### Comment (#140, 412, #413, #414,#415, #416, #417):

### PSE-PD stability

#### 33A.1 Recommended PSE design guidelines and test setup

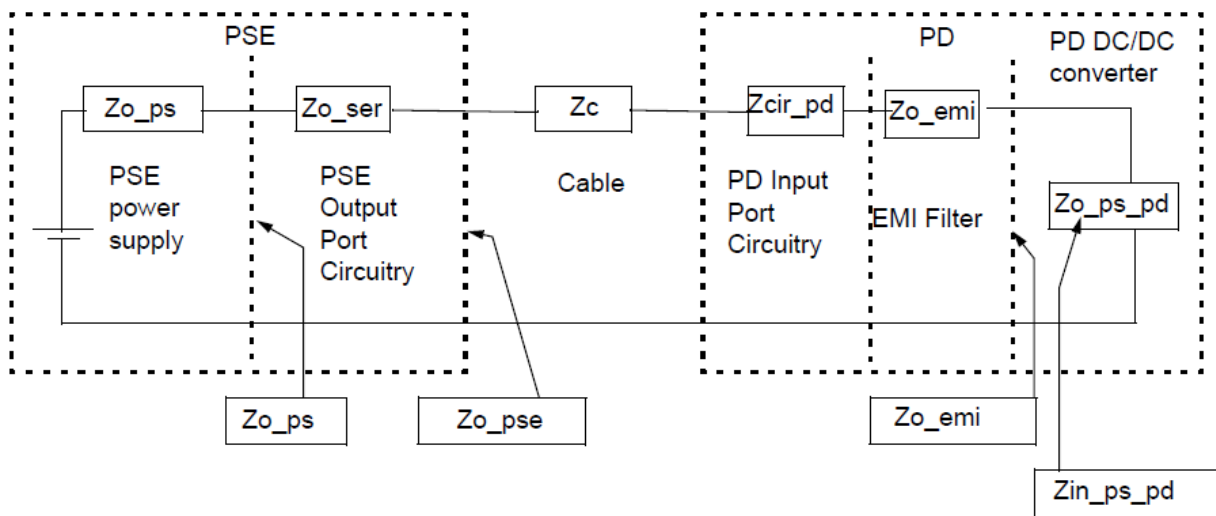
1. TDL #275 and #276 D2.1 (comments: #108, #420, #421, #281 D2.2) was not fully implemented.
2. In addition, editor has noted that due to comment #452 D2.2 (removal of PPort\_PD) we can't use the term PPort\_PD. 33A.1 was written to address Type 1 PSE and PD. It is still relevant for Type 2 PSE. It was updated not to address Type 3 and Type 3 system therefore it should be limited for clause 33 only. As a result, Pport\_PD term can be use.
3. To move this material to clause 33 and file maintenance request.

- $Z_{o\_ps\ max} = 0.3\ \Omega$  at frequencies up to 100 kHz at the highest output power level that the PSE supports, as defined in Table ~~33-13~~33-7 At lower power  $P_{pse\_actual}$ ,  $Z_{out\_ps\_max} = 0.3\ \Omega \times P_{Class} / P_{pse\_actual}$ .  $P_{pse\_actual}$  is the actual power that the PSE support below PClass.  $Z_{o\_ps}$  can be extracted from  $Z_{o\_port}$  by measuring VPort\_PSE-2P/ IPort (with an external power dynamic analyzer system) as a function of frequency and subtracting from  $Z_{o\_port}$  the value of  ~~$Z_{ser}$~~  $Z_{o\_ser}$  which is limited by the value of  $Z_{o\_ser}$  at DC (low frequency).

~~— If  $Z_{o\_ps} < Z_{o\_ser}$  and VPort 2P is kept to VPort 2P min and VPort 2P max as defined in Table 33-17 during dynamic load changes from 10 Hz to 100 kHz, then the value of  $Z_{o\_ps}$  is not limited.~~

- The value of  $Z_{o\_ps}$  is not limited if the following conditions are met simultaneously:

- 1)  $Z_{o\_ps} < Z_{o\_ser}$
- 2)  $V_{pse}$  is kept in the range of  $V_{Port\_PSE-2P}$  as defined in Table 33-17 33-11 during dynamic load changes from 10 Hz to 100 kHz.

See Figure 33A-1 for the PSE-PD system impedance allocation.
